Approved Section 4.55 (.....2.....) Modification Application

In respect to.....SSD 7484.....

SANDSTONE PRECINCT
23-39 BRIDGE STREET
SYDNEY, NSW, 2000

DEMOLITION ELEVATIONS LANDS BUILDING - SOUTH AND EDUCATION BUILDING - SOUTH

4 LEVEL 9 GARDEN VILLAS MAINTENANCE ACCESS DOOR
1:20

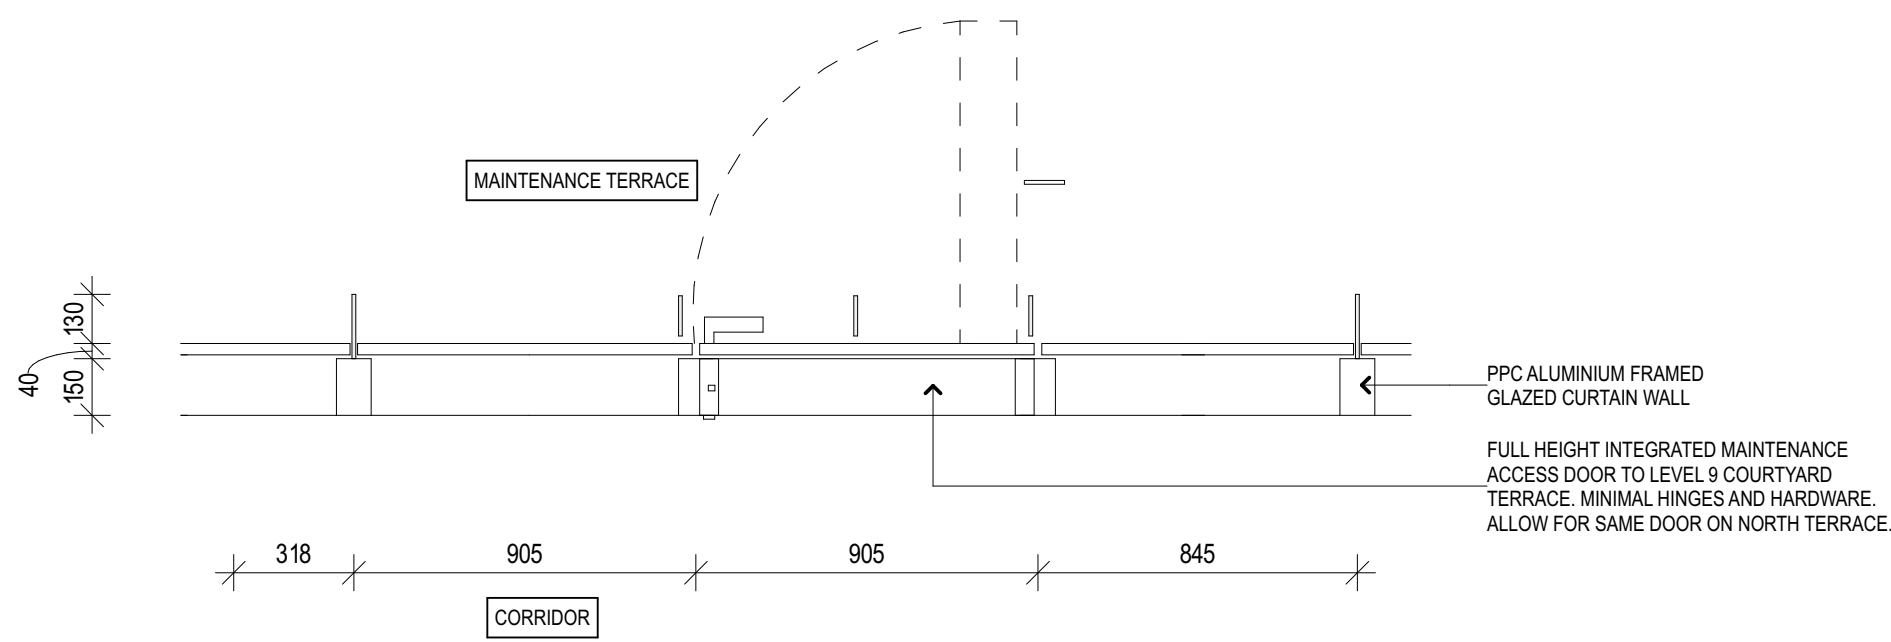
CHANGES LEGEND:	
01	ADDED BALUSTRADE

TITLE
**FAÇADE DETAILS - EDUCATION BUILDING -
LEVEL 9 INFILL CLADDING**

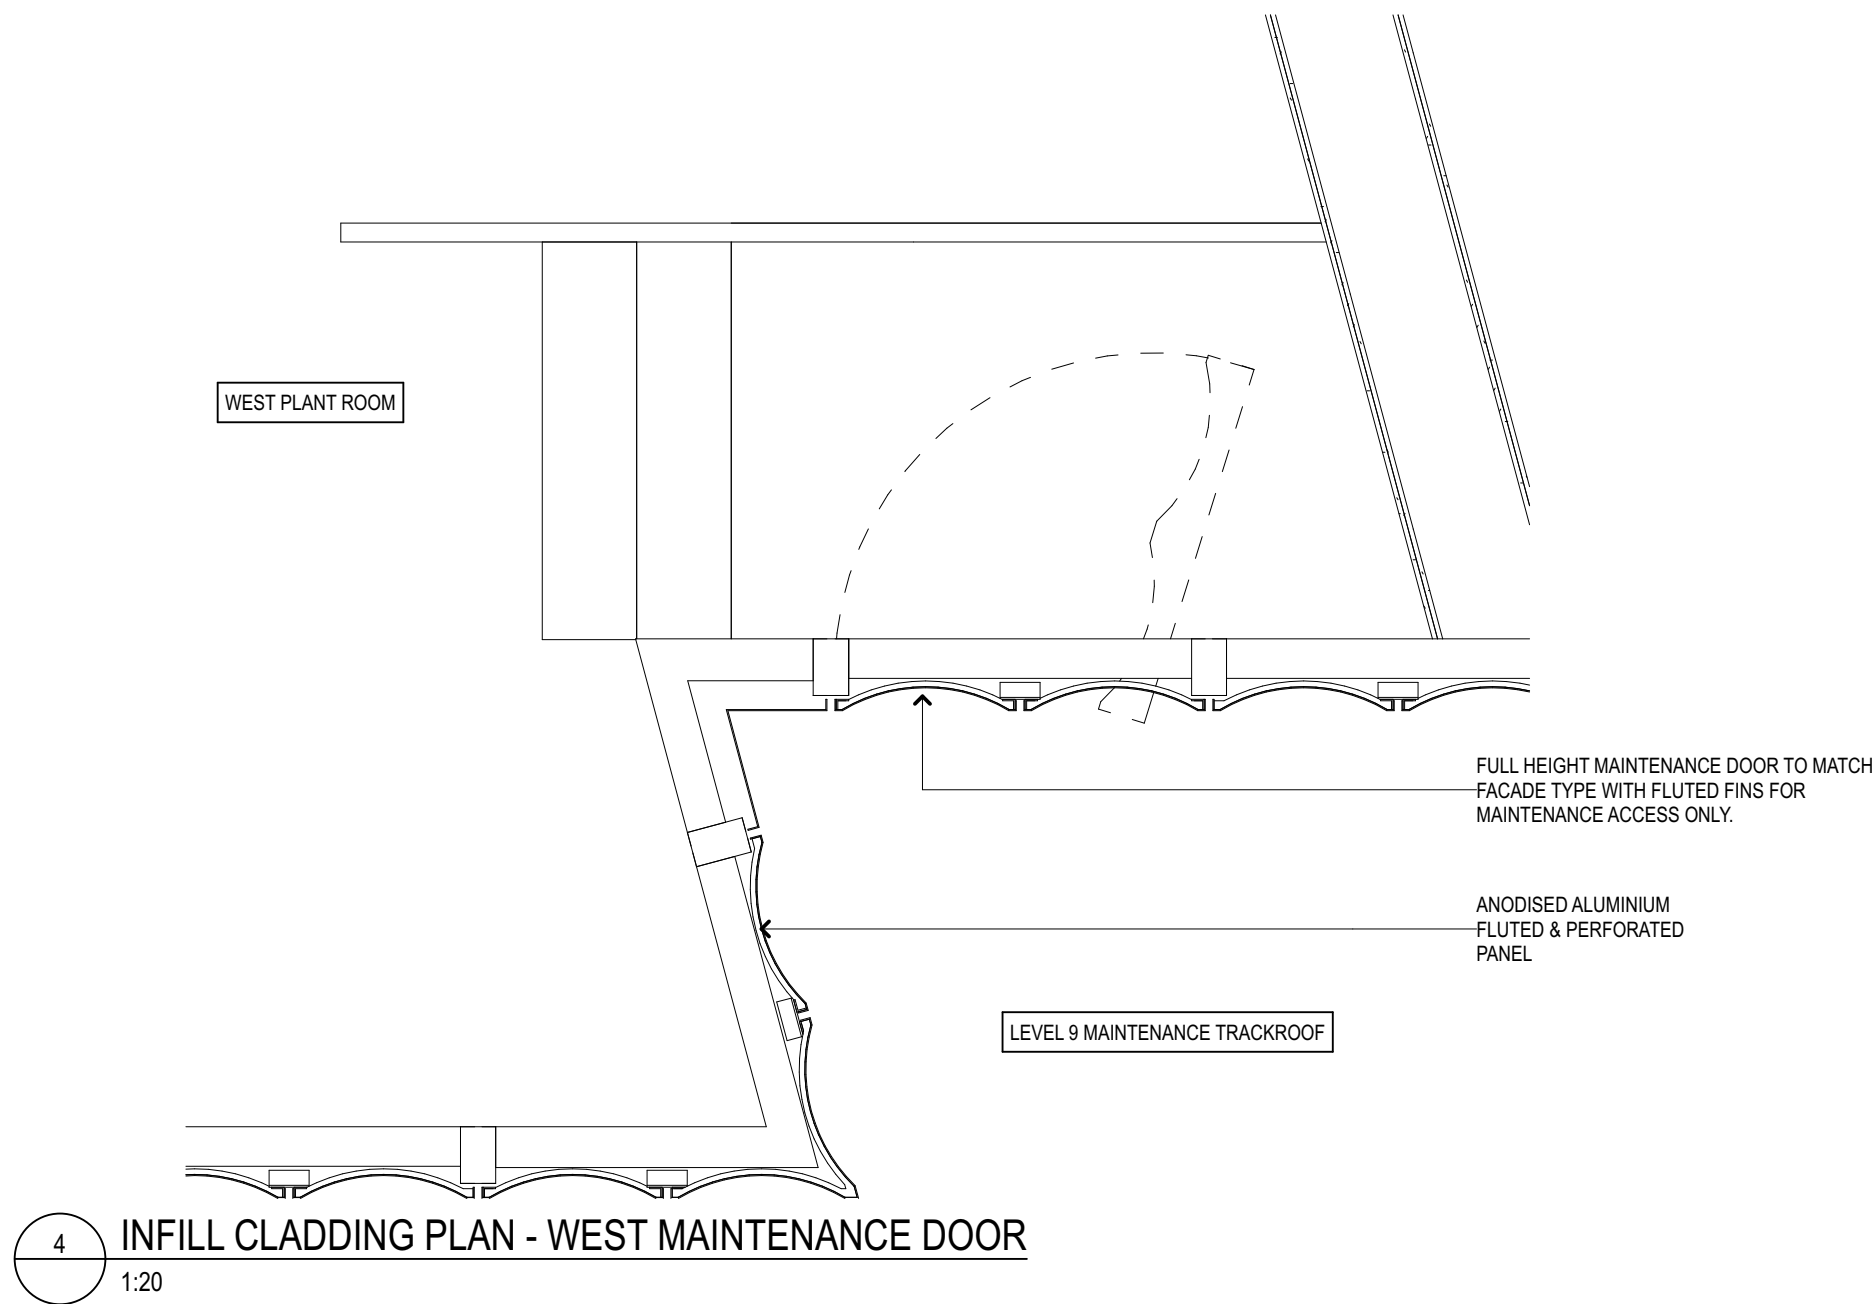
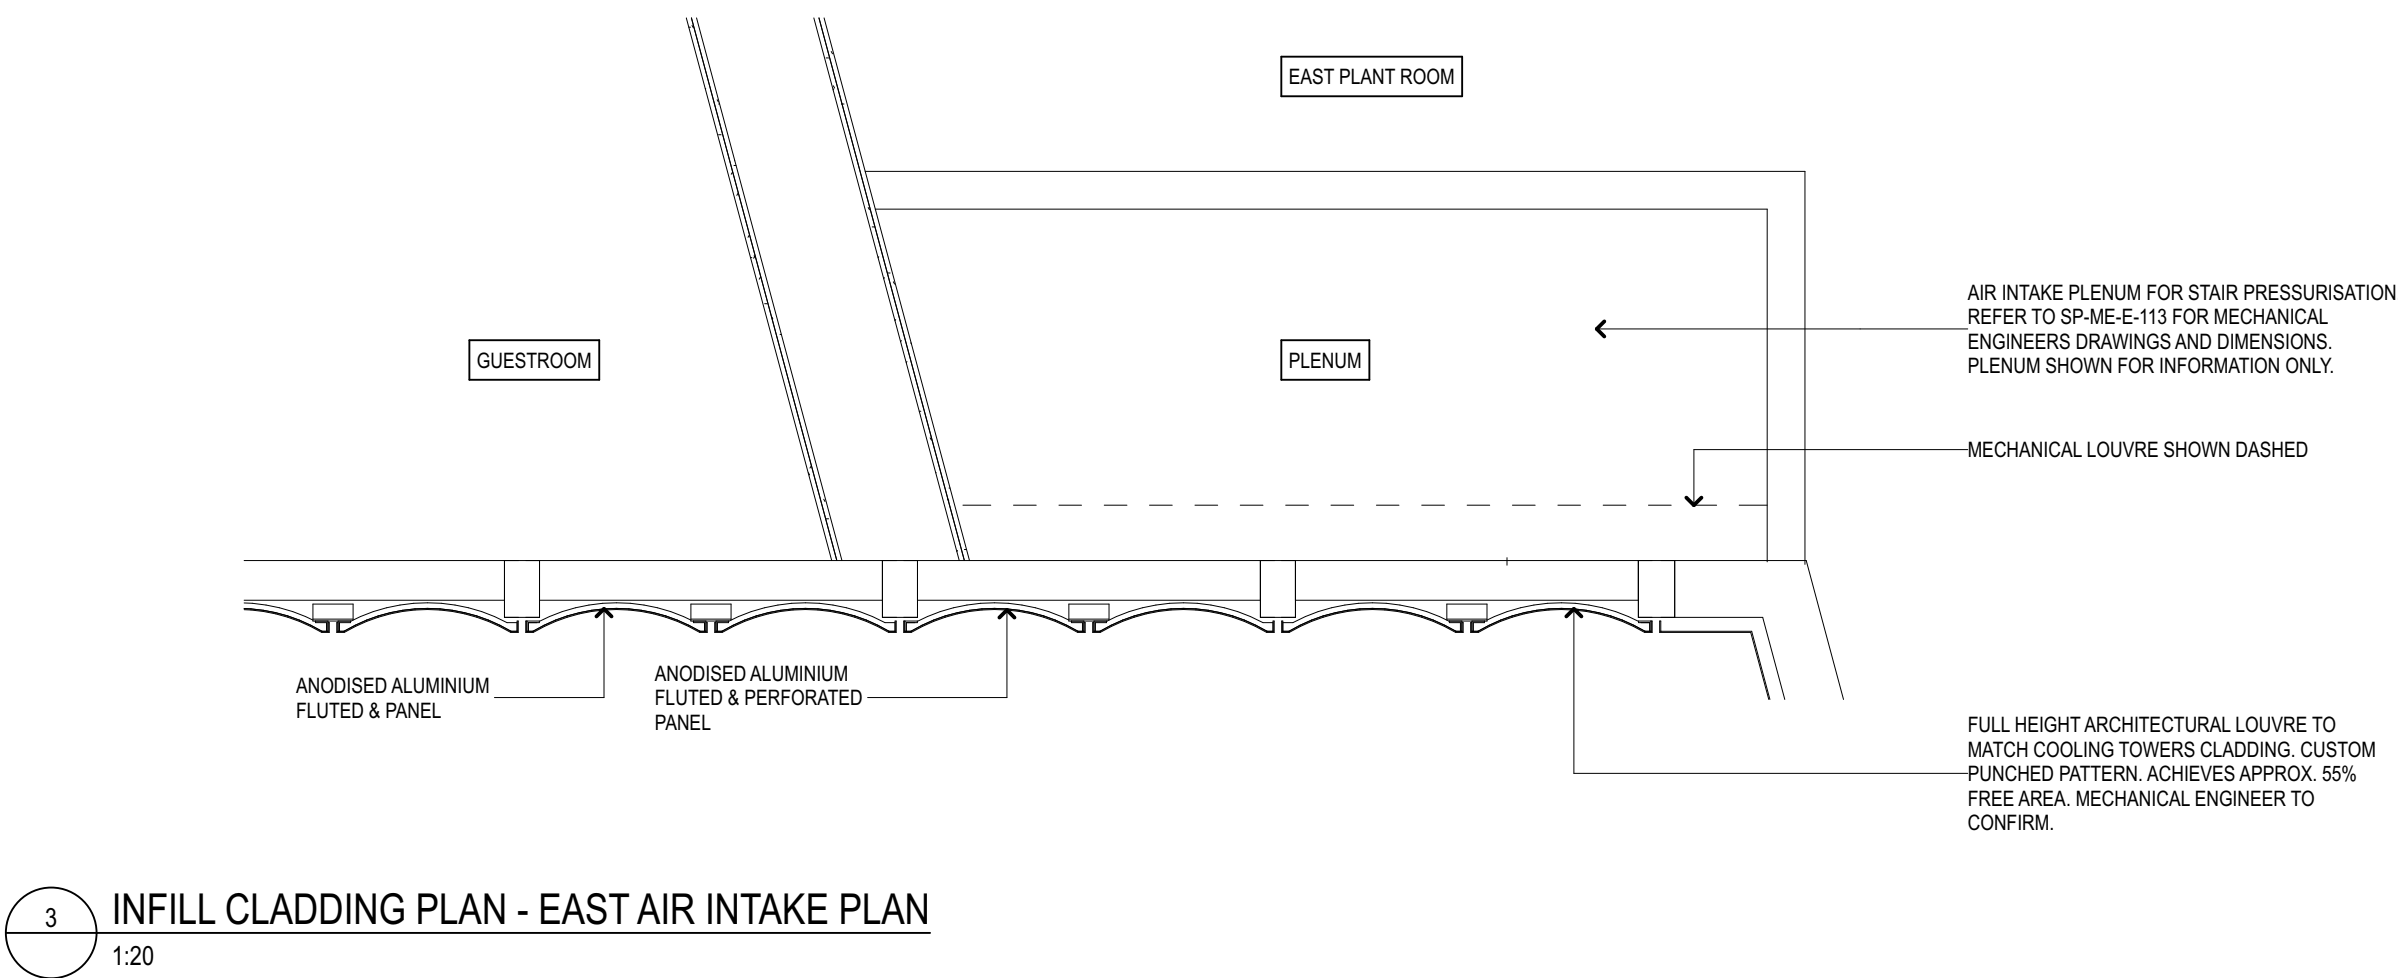
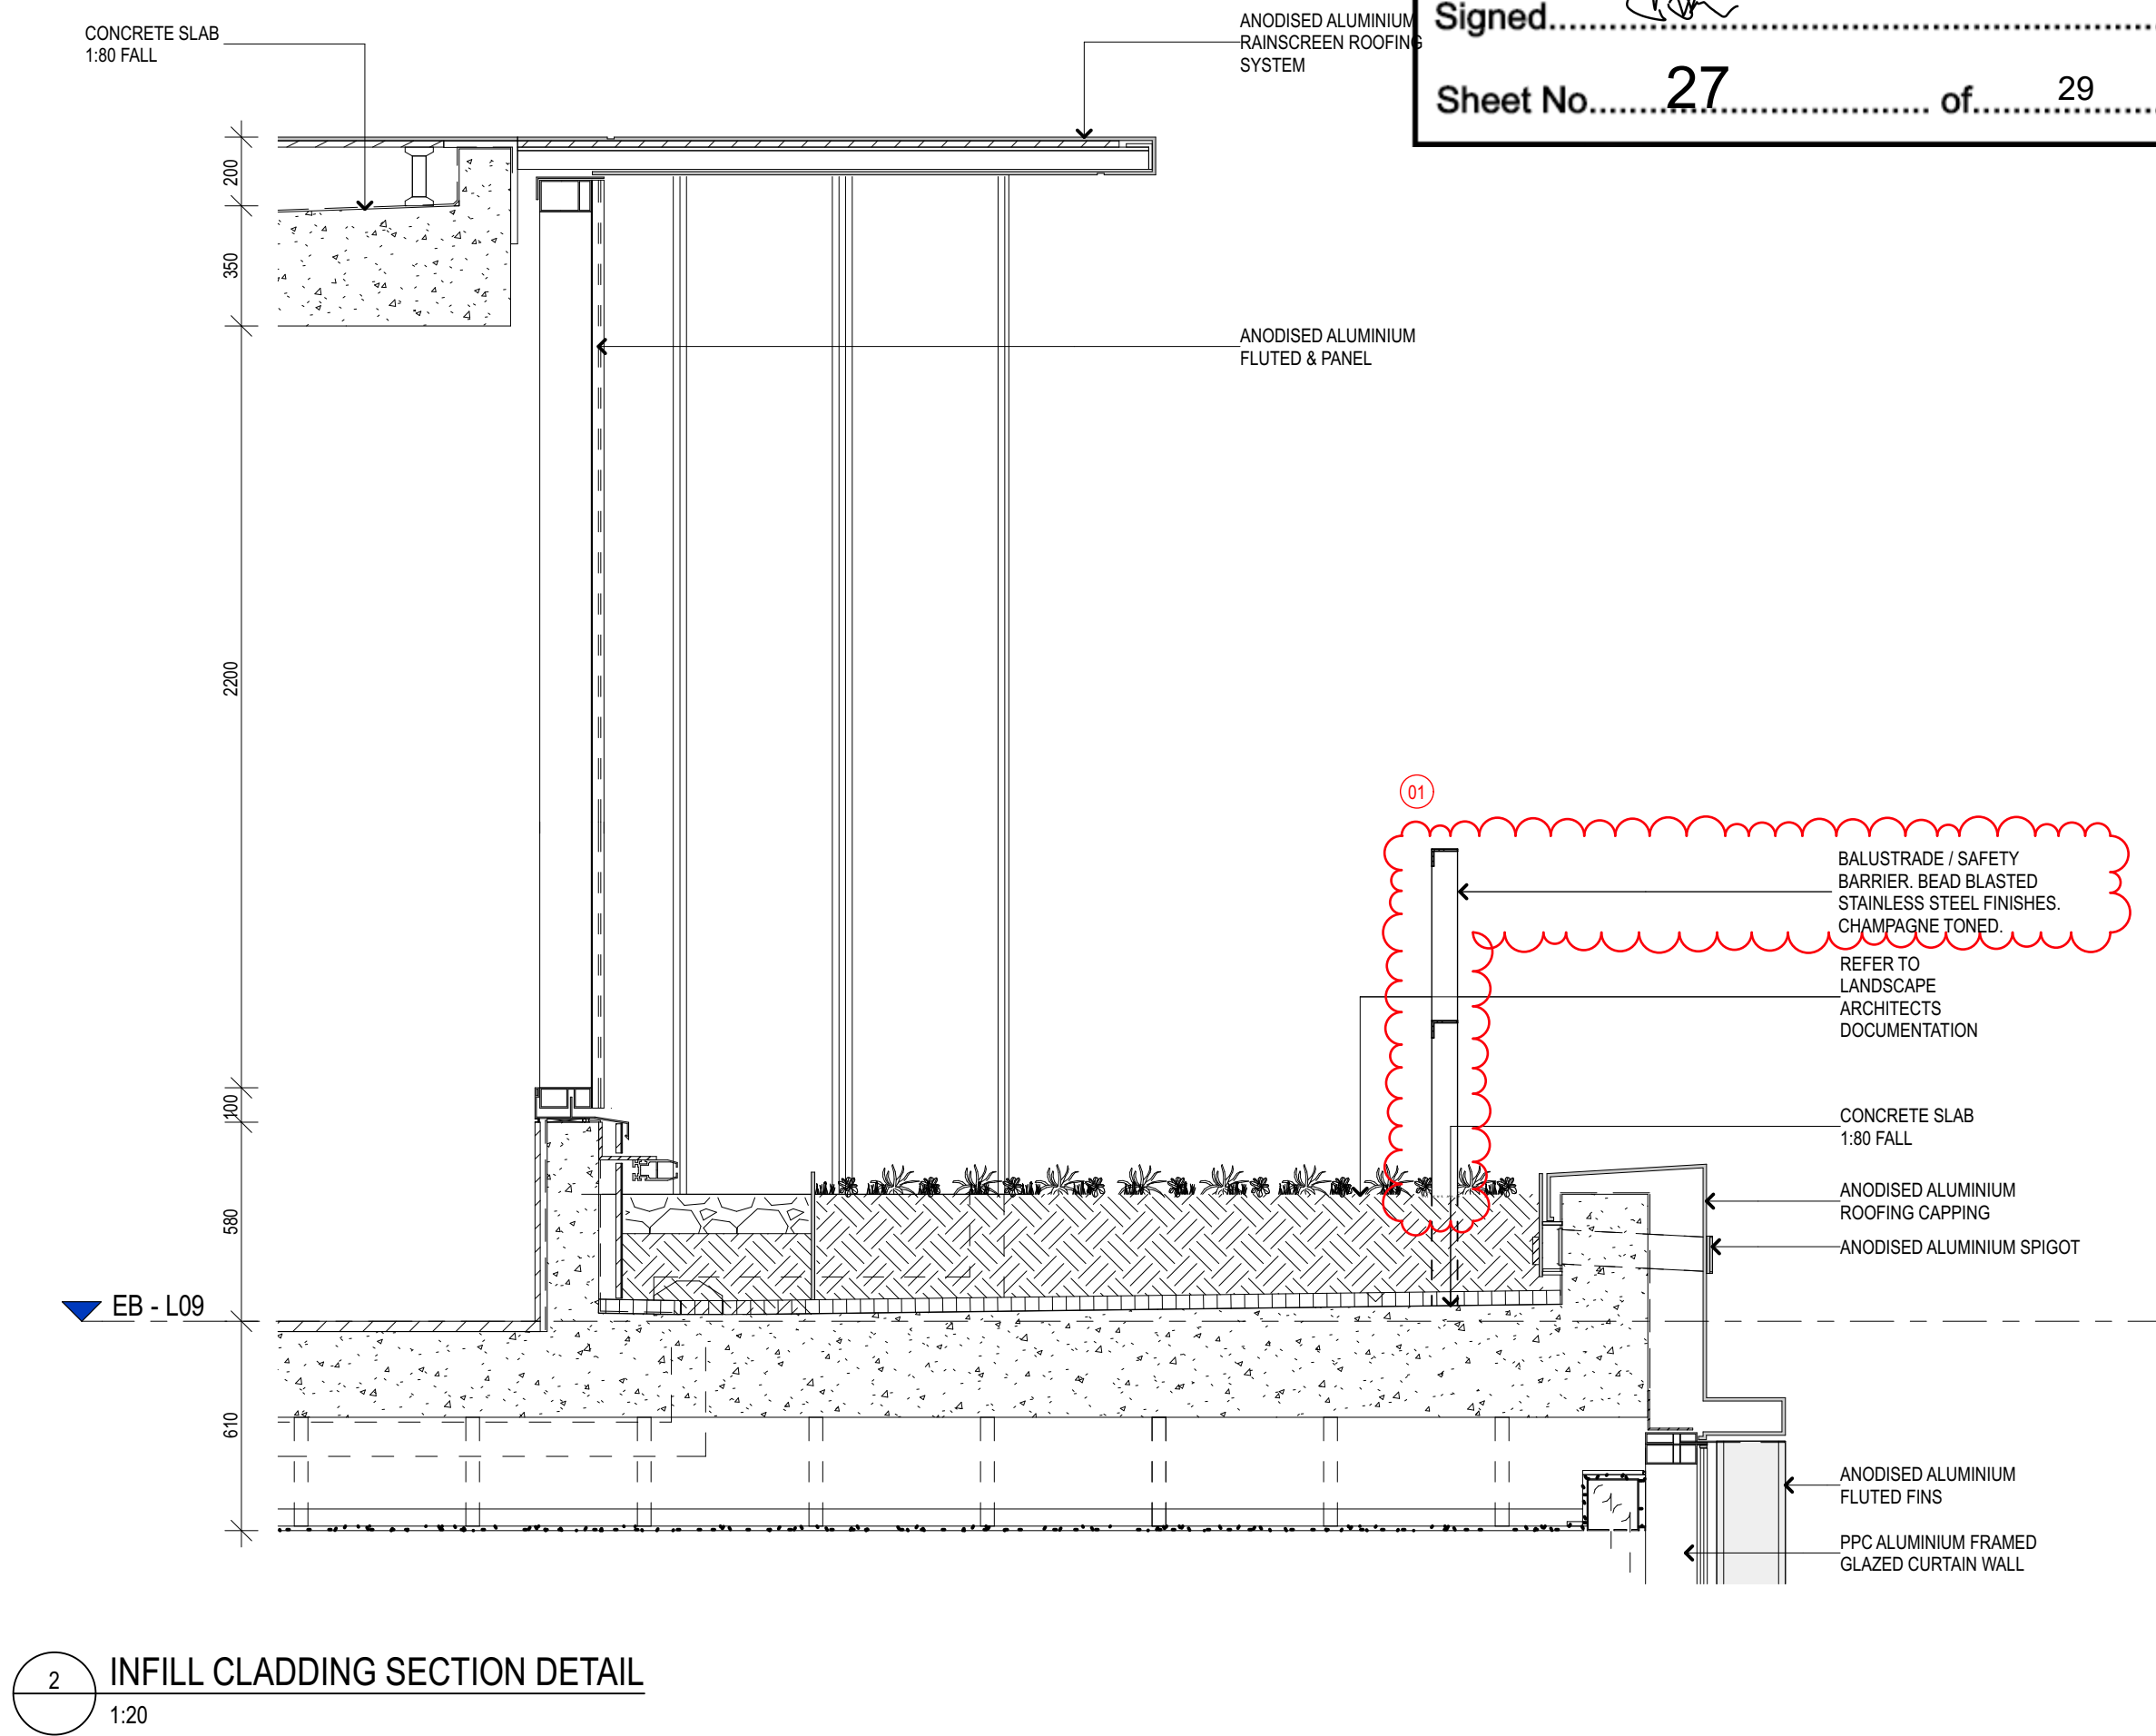
CHANGES LEGEND:
(01) ADDED BALUSTRADE
